CITY OF FRANKLIN
PLAN COMMISSION MEETING*
FRANKLIN CITY HALL COUNCIL CHAMBERS
9229 W. LOOMIS ROAD, FRANKLIN, WISCONSIN
AGENDA
THURSDAY, MAY 5, 2022, 7:00 P.M.

1. **BEAR DEVELOPMENT, LLC RISE COMMERCIAL DISTRICT WAREHOUSE/OFFICE MULTI-TENANT INDUSTRIAL DEVELOPMENT AND ASSOCIATED PARKING WITHIN RYAN MEADOWS SUBDIVISION.** Natural Resource Features Special Exception application by Stephen R. Mills, President of Bear Development, LLC (Loomis & Ryan, Inc. and Gurjit Singh and Gurmit Kaur, property owners) and Site Plan application by Jim R. Sapp, President of RISE Commercial District (Loomis & Ryan, Inc., property owner), as follows:
Natural Resource Features Special Exception: for the purpose of impacting approximately 14,939 square feet of wetland buffer (11,558 square feet of temporary impacts (grading and site disturbance) and 3,381 square feet of permanent impacts (paving and partial locations of five of the proposed buildings) and approximately 13,416 square feet of wetland setback (228 square feet of temporary impacts (grading and site disturbance) and 13,188 square feet of permanent impacts (paving and partial locations of five of the proposed buildings), with proposed impacts

LANDSCAPE OVERVIEW

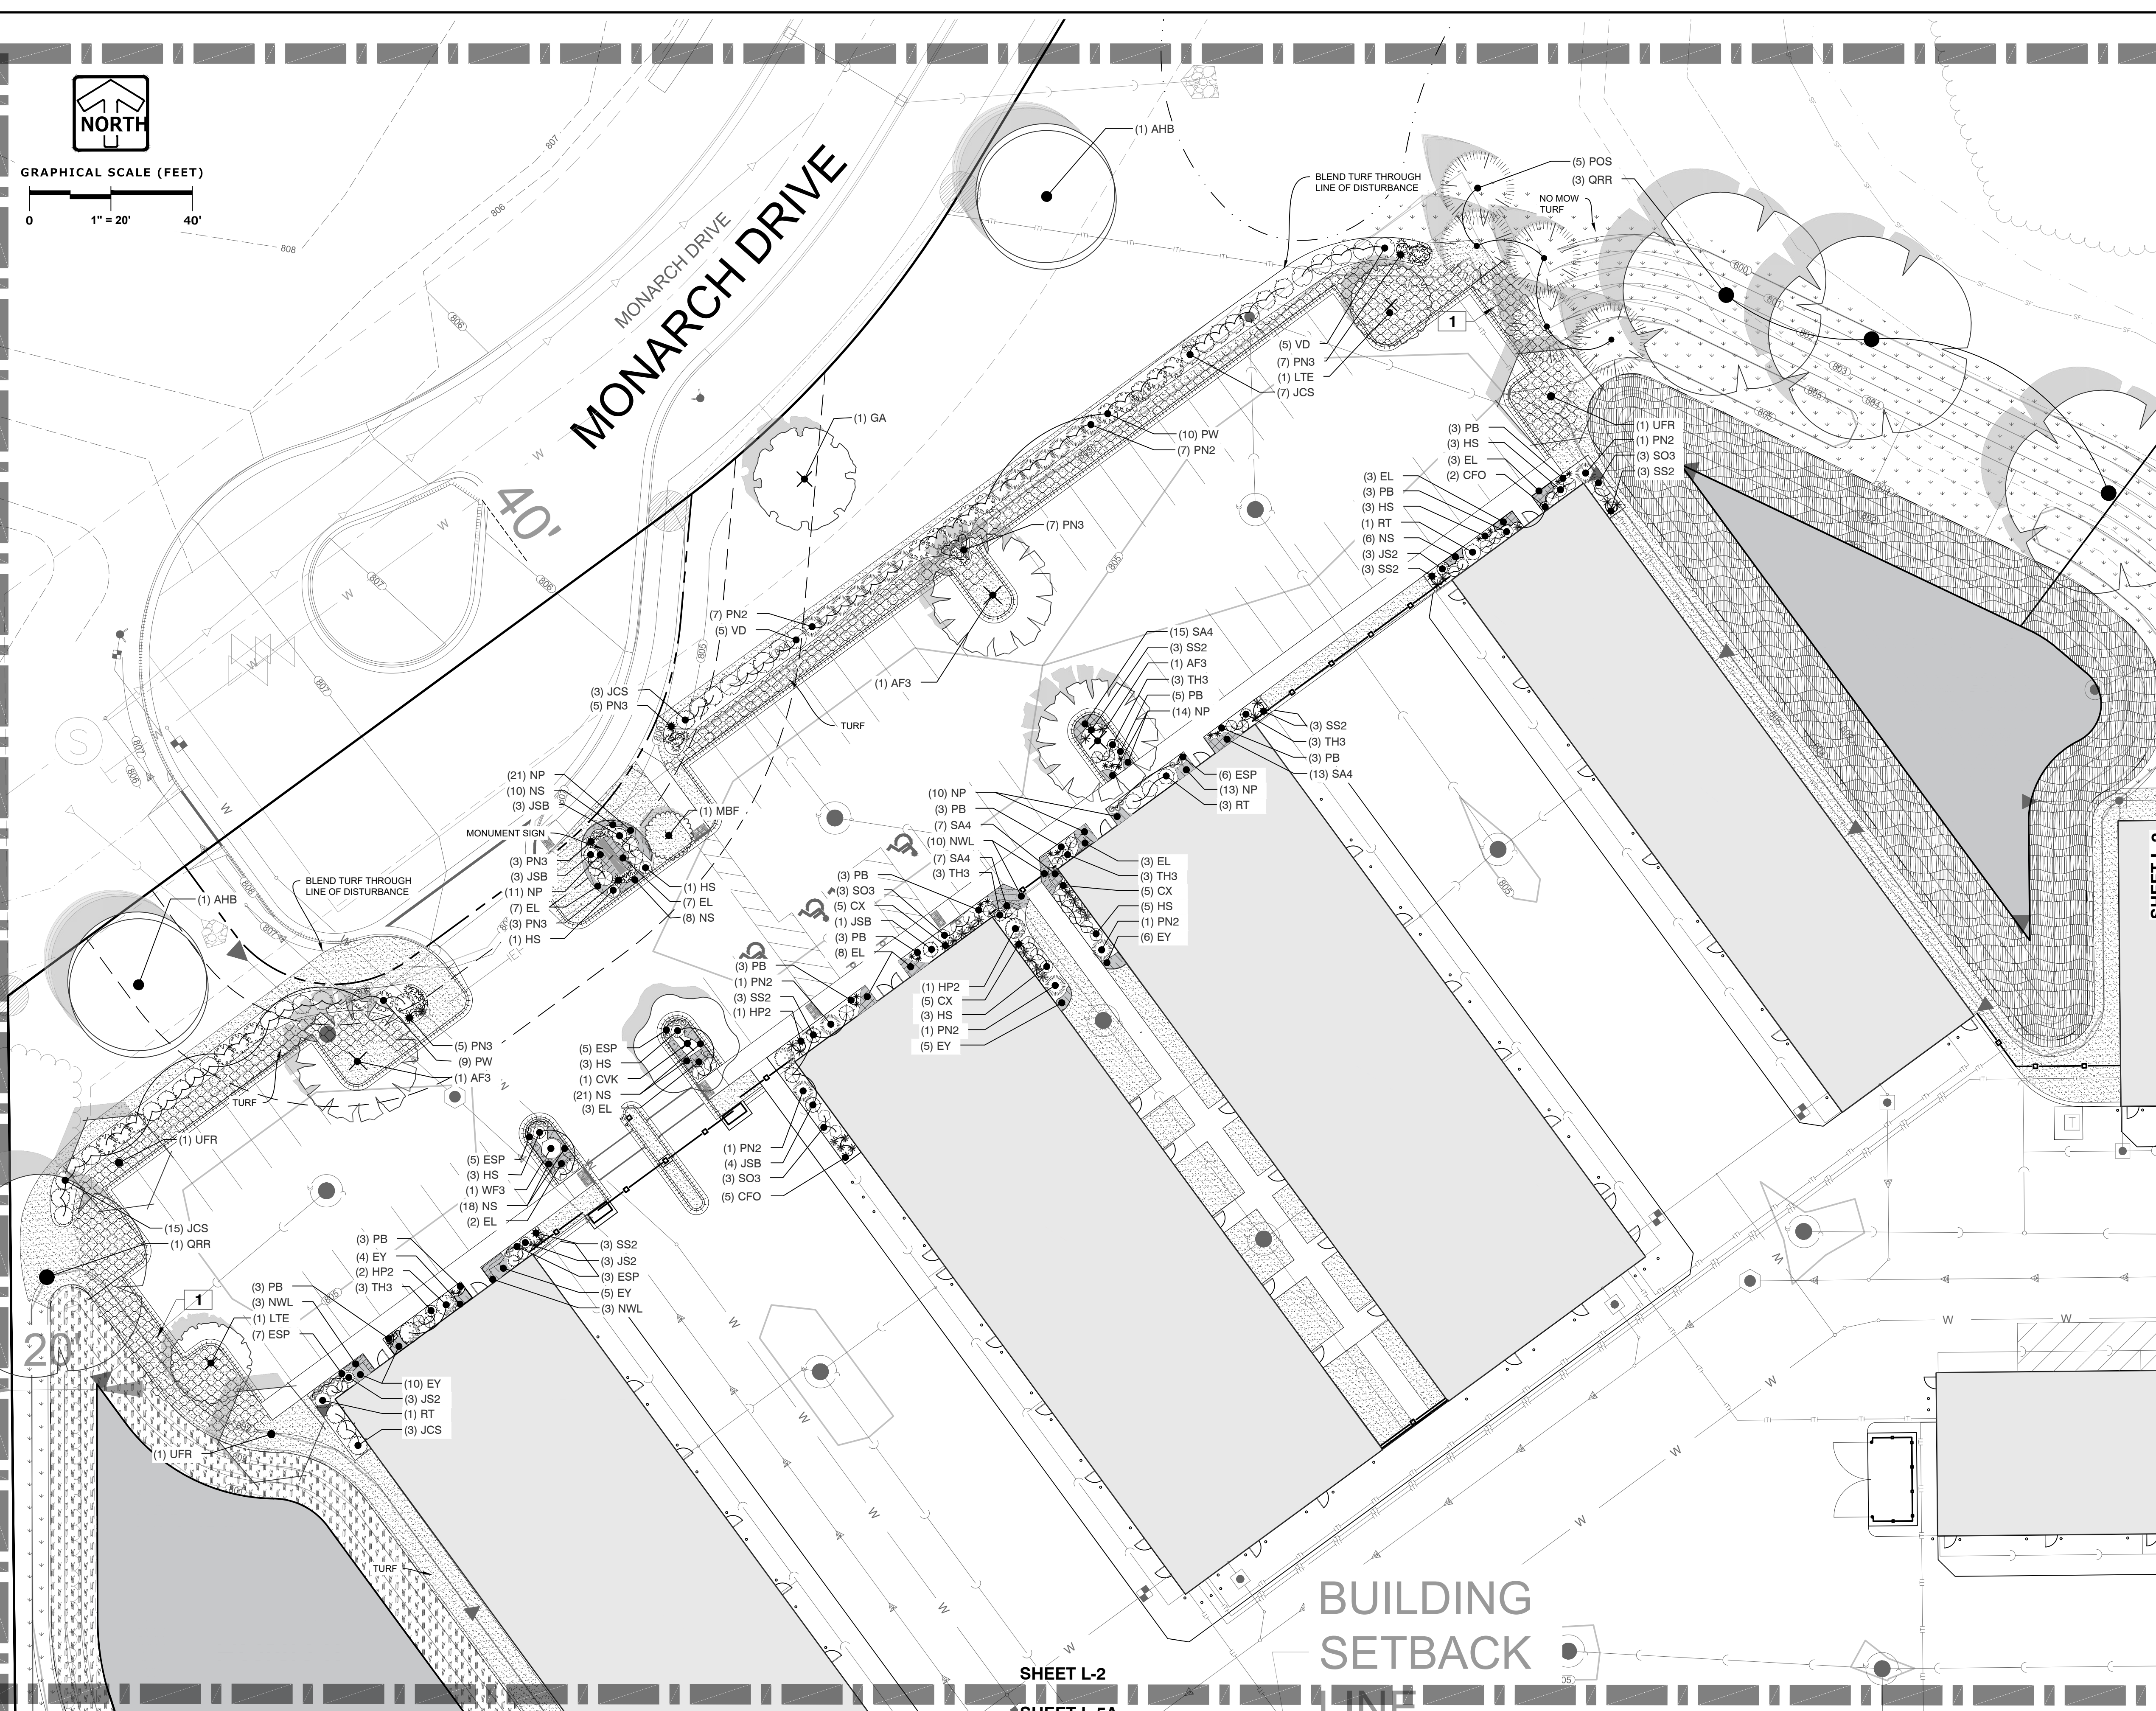
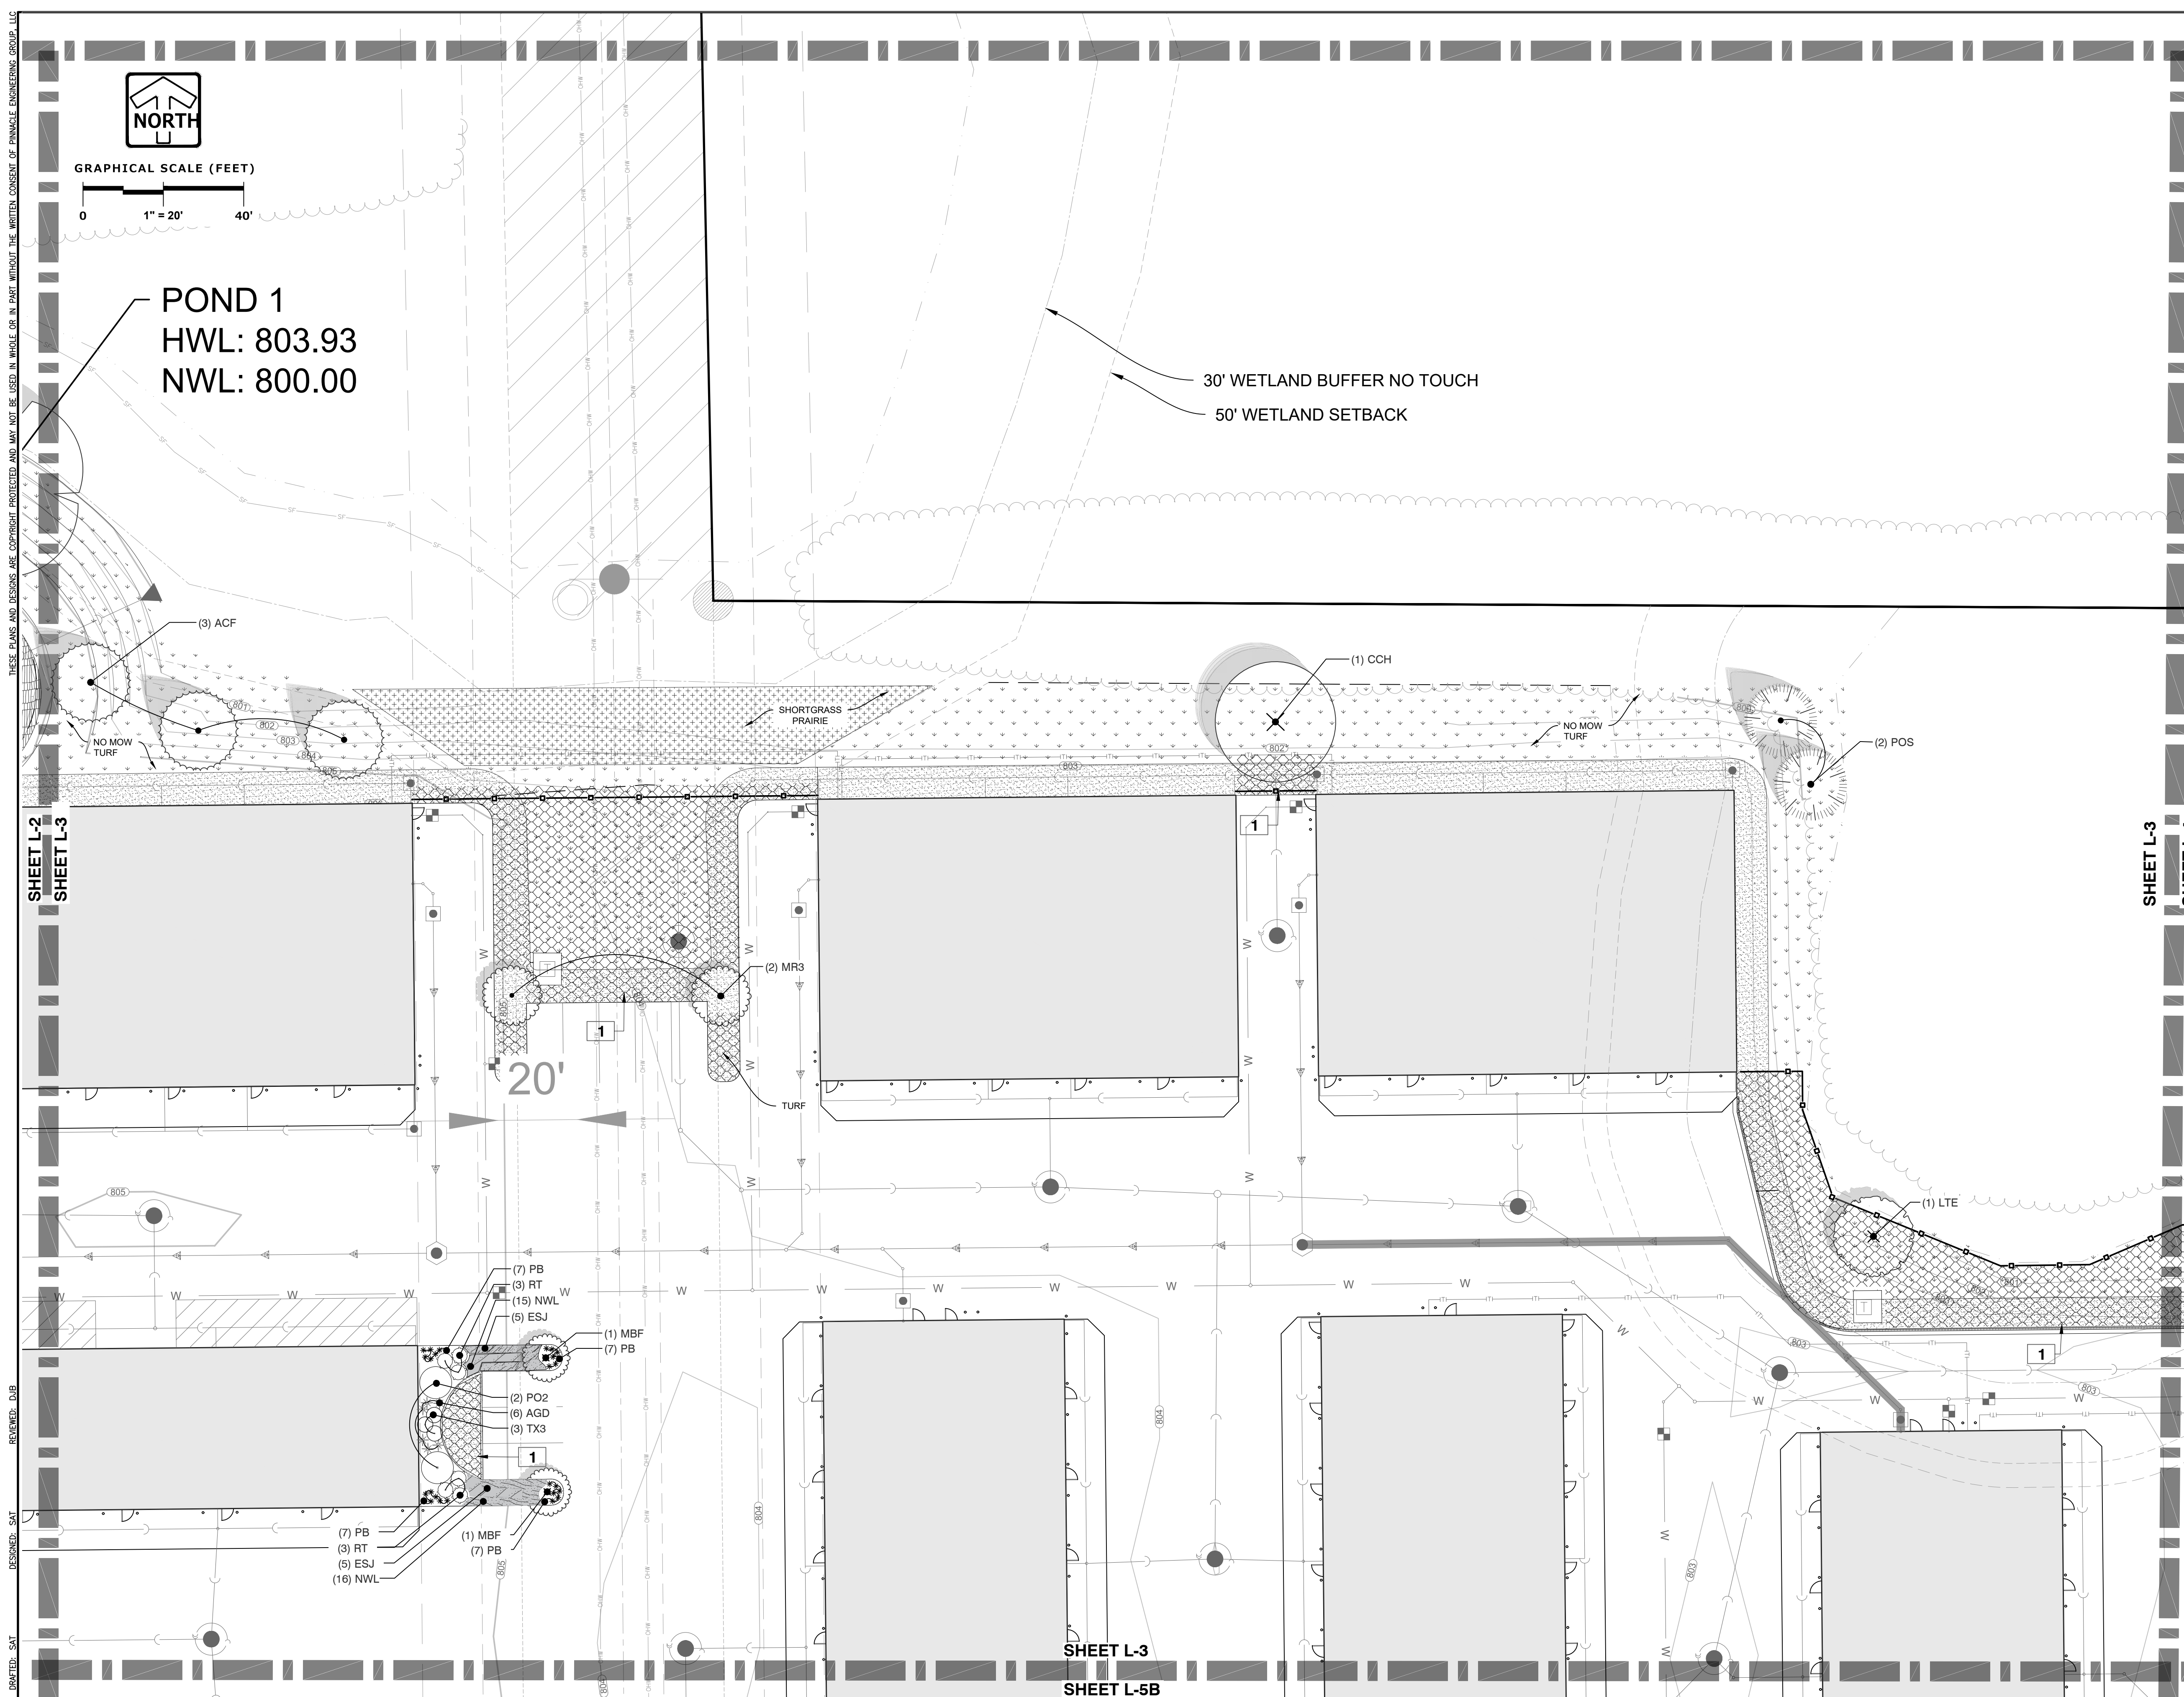
5. The applicant shall revise the plant schedule of the Landscape Plan (sheet L-1), specifically the quantity of proposed evergreen trees to comply with the Unified Development Ordinance (UDO) Section 15-5.0302.F, which states that no one species shall exceed 35% of species planted within a planting type.

20. **Canopy/Shade trees planting size.** Per UDO Table 15-5.0302 “Minimum Number Plant Standard Plant Units” (below), the minimum planting size for canopy/shade trees is 2.5 inch caliper. Please revise the plant schedule (sheet L-1) accordingly.
